REPORT

SUBJECT: Recommendation Report, Draft Plan of Subdivision and Zoning By-law Amendment, Spruce Rose Inc., 304 & 318 Spruce Street – File Nos. 24T-24003/1613 and Z.1613.66

LOCATION: 304 & 318 Spruce Street

Figure 3 – Proposed Draft Plan of Subdivision

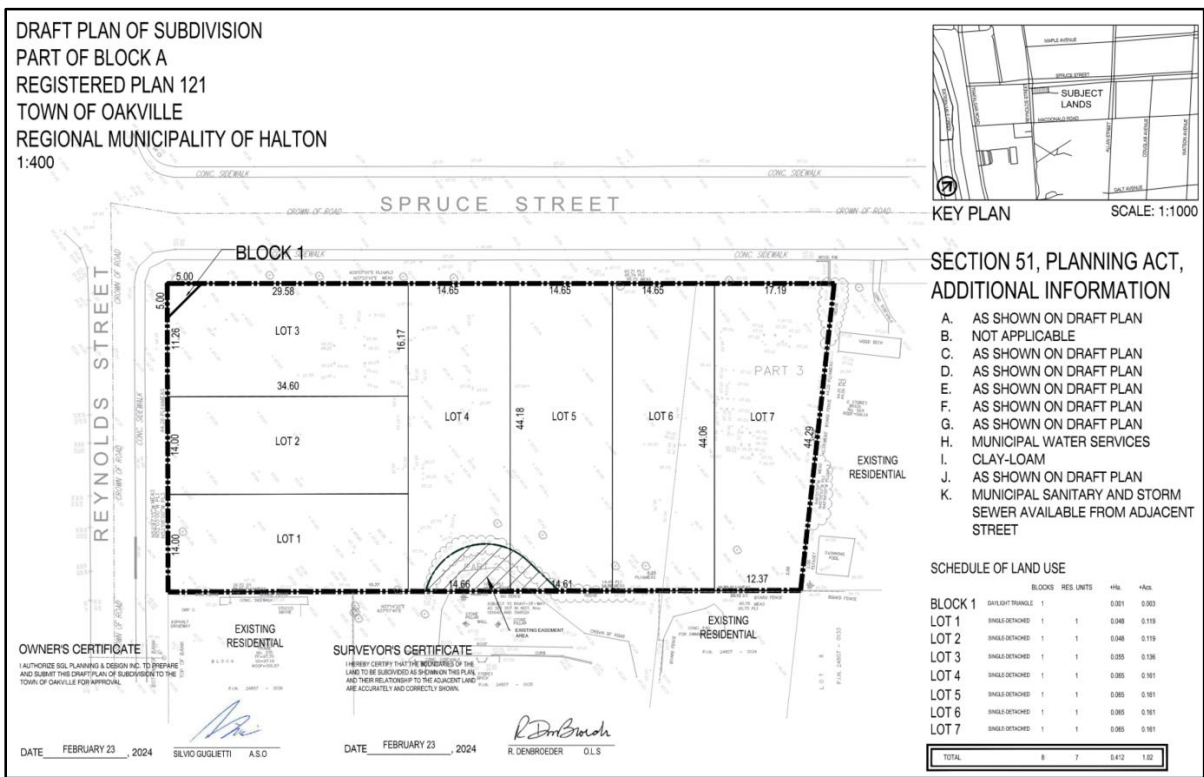
Staff notes that the proposed lotting pattern in terms of frontage and shape of the proposed Lots 1-3 do not meet the configuration of the adjacent properties to the south and across the street and therefore does not meet the criteria of Section 51(24)(f) of the *Planning Act*. The proposed lot configuration for Lots 1-3 would result in narrower and deeper dwellings that would not meet the predominant lotting pattern for lots fronting Reynolds Street between Spruce Street and MacDonald Road and therefore does not conform to the Official Plan policies of compatibility (Section 11.1.9.d) and consequently the Section 51(24)(c) of the *Planning Act*. There are also concerns raised by Engineering staff about the adequacy of easement widths provided for stormwater management as well as the feasibility of the berm located along the eastern property boundary of Lot 7. Notwithstanding, it is staff's opinion that the proposed subdivision to develop detached dwellings is appropriate at the subject lands and therefore meets the criteria of Section 51(24)(d) of the *Planning Act*.

Staff notes that due to the concerns raised by Engineering staff, Transportation staff, Heritage staff and Urban Design staff, the proposed Draft Plan of Subdivision may require further revisions and modifications (i.e less lots or reconfigured lots). The applicant has not addressed concerns raised by staff which were provided to the applicant in a consolidated comments report on May 24, 2024. For this reason, staff is of the opinion that the Draft Plan of Subdivision application should be refused.

Figure 4 – Proposed building siting

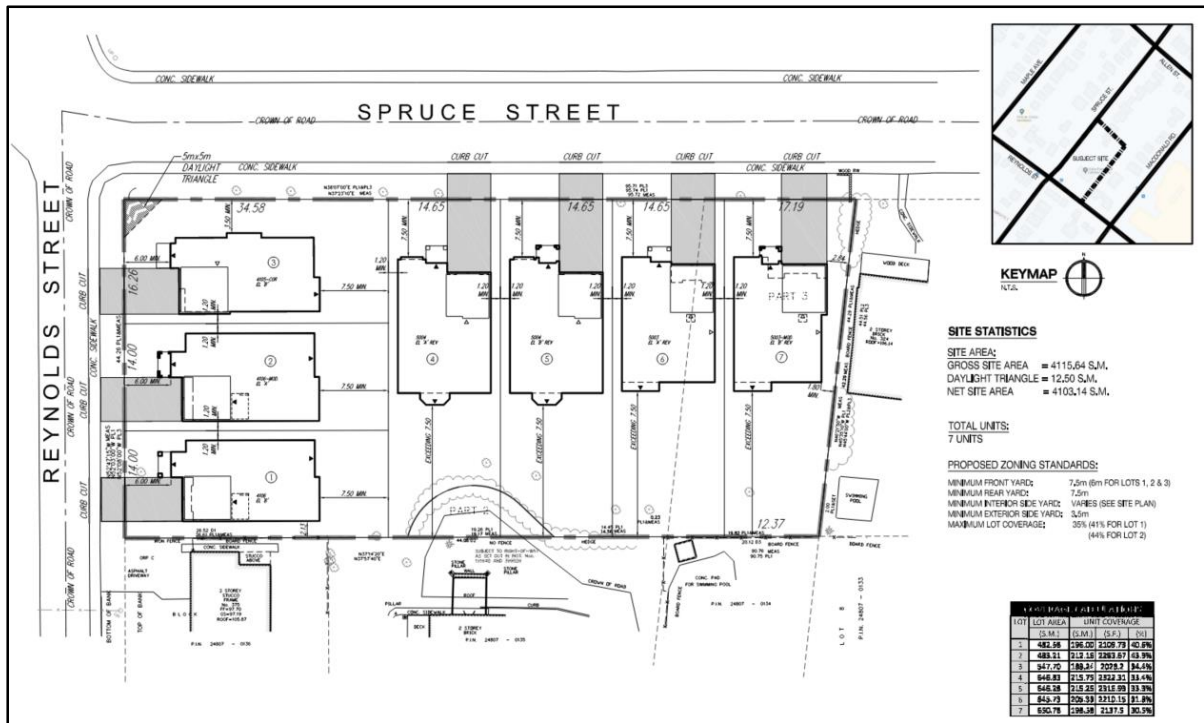
It is noted that the conceptual site plan provided by the applicant shows the front yard setback measured from the front property line to the front main wall of the dwelling, excluding the porch. The proposed porches are shown to encroach the minimum front yard setbacks. As per Zoning By-law 2014-014 the front porches are subject to the minimum front yard requirements, and a revision of the conceptual site plan would be needed.

According to the applicant's proposed Zoning By-law, Lots 1 and 2 are proposed to have a lot coverage of 44%. The concept plan (Figure 4) provided with the application for proposed Lots 1 & 2, Lot 1 has a proposed lot coverage of 40.6%, while Lot 2 is proposed to have 43.9%. The RL5 Zone requirement a lot coverage requirement of 35%, whereas, the RL3-0; SP10 requirement is 19% for two-storey detached dwellings.

Figure 12 – Lotting Pattern of lots fronting Reynolds Street between Spruce Street and MacDonald Road

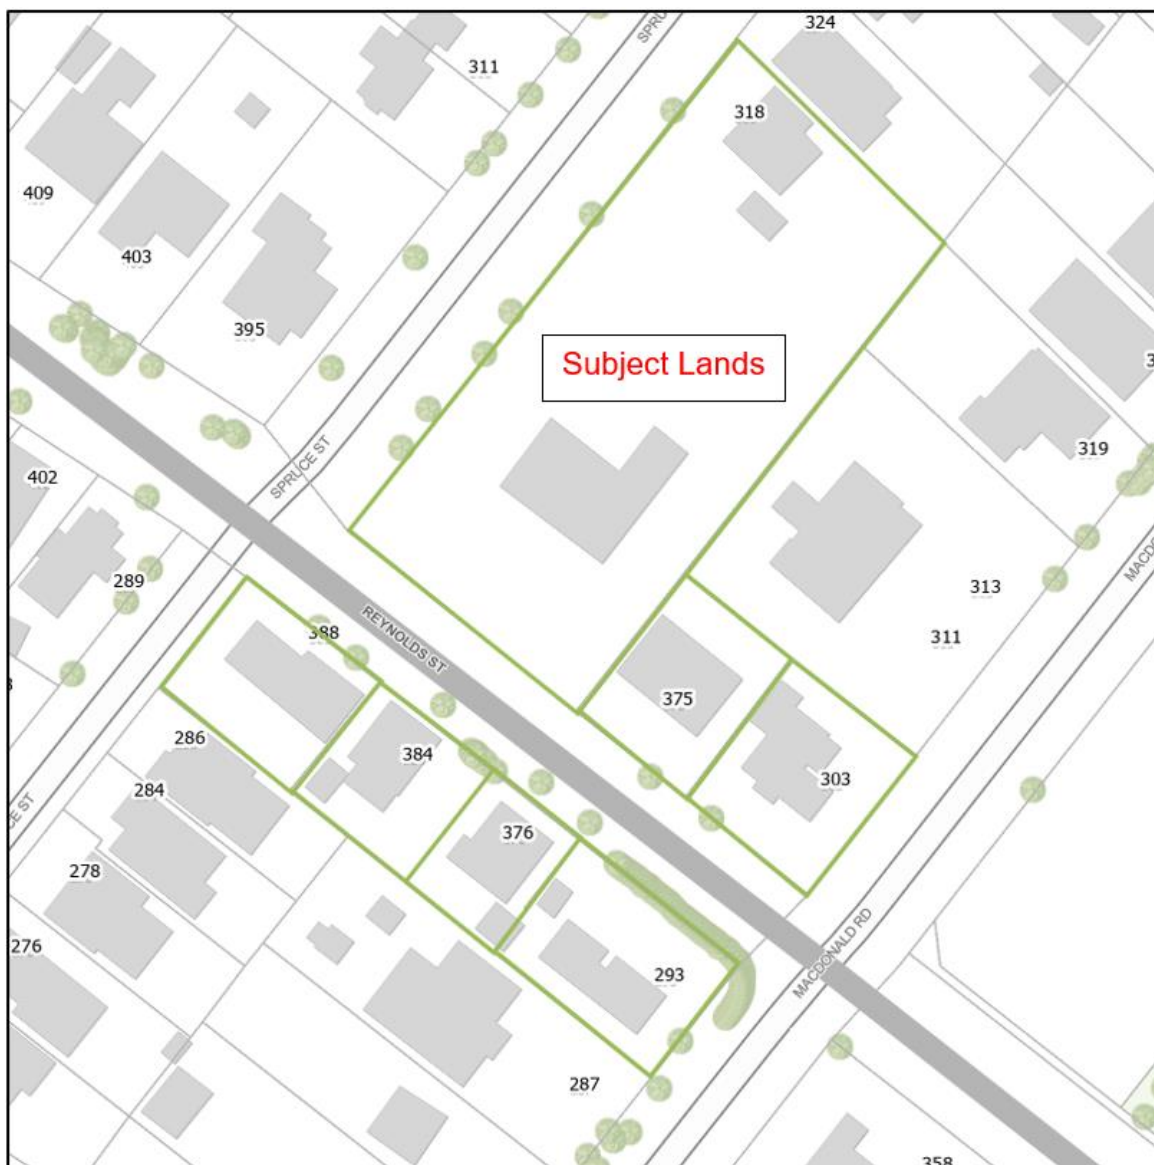
The lotting pattern in terms of shape and frontage of the proposed lots fronting Reynolds Street does not align with the lotting pattern of the existing lots on

Reynolds Street between Spruce Street and MacDonald Road. These include existing lots immediately south of the subject lands and lots to the west across Reynolds Street between Spruce Street and MacDonald Road as shown in Figure 12 below. The lot configuration of the proposed dwellings varies from the existing Reynolds Street lots between Spruce Street and MacDonald Road which have larger frontages. The proposed lot configuration of Lots 1-3 results in narrow frontages, and are significantly deeper than the existing lots fronting Reynolds Street between Spruce Street and MacDonald Road. This inconsistency in the lotting pattern would consequently create narrower and deeper dwellings that do not maintain the visual continuity of the streetscape.
